## Exhibit 16

SUBJECT: TRC COMMENTS FOR CUBES SELF-STORAGE, PL2018-0013

Re: Review Comments for Cubes Self Storage

subject Cubes Self Storage – Critical Areas Report and Conceptual Mitigation Plan Review

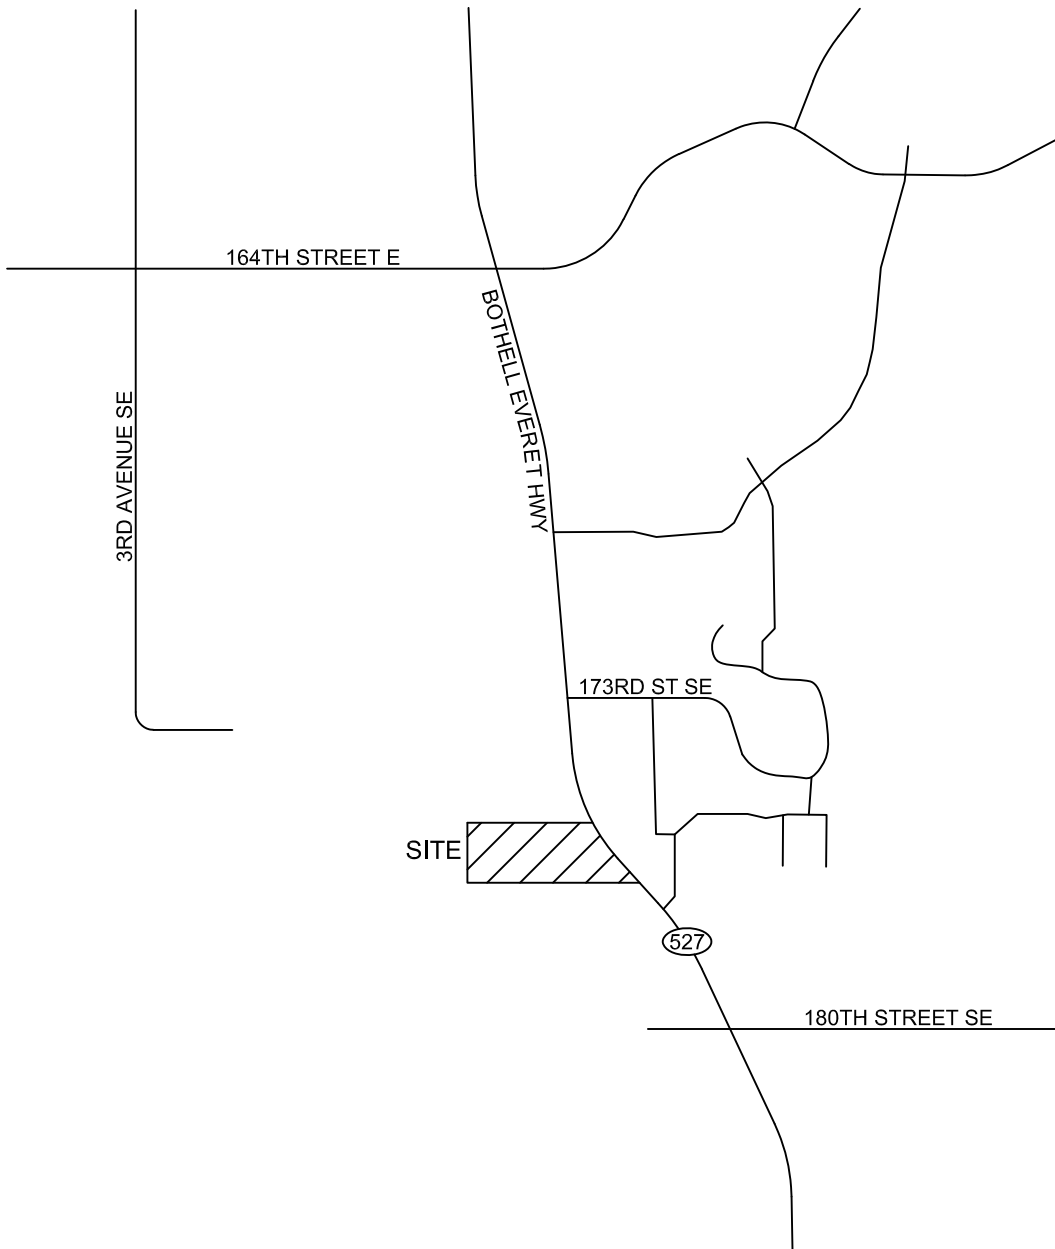
90,425

Use 2.46 developed acres for the calculations - rather than 4 acres. Or use actual counts as recommended by Pertert.

90,425

2.46
